### **Proposal for the 09 series of amendments to UN Regulation No. 14 (Safety-belt anchorages)**

#### **Submitted by the Working Party on Passive Safety\***

## **09 series of amendments to UN Regulation No. 14 (Safety-belt anchorages)**

Model A

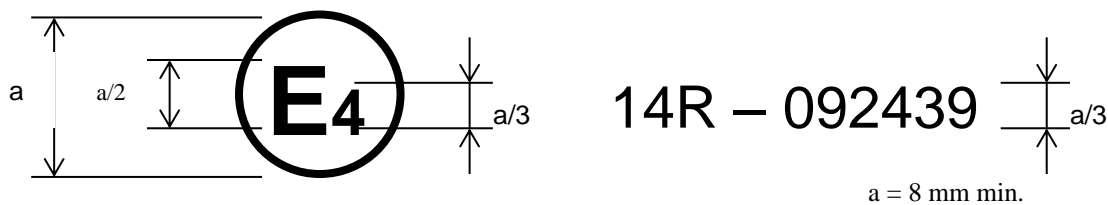
Annex 2, amend to read:

The above approval mark affixed to a vehicle shows that the vehicle type concerned has, with regard to safety-belt anchorages, been approved in the Netherlands (E 4), pursuant to UN Regulation No. 14, under the number 092439. The first two digits of the approval number indicate that UN Regulation No. 14 already included the 09 series of amendments when the approval was given.
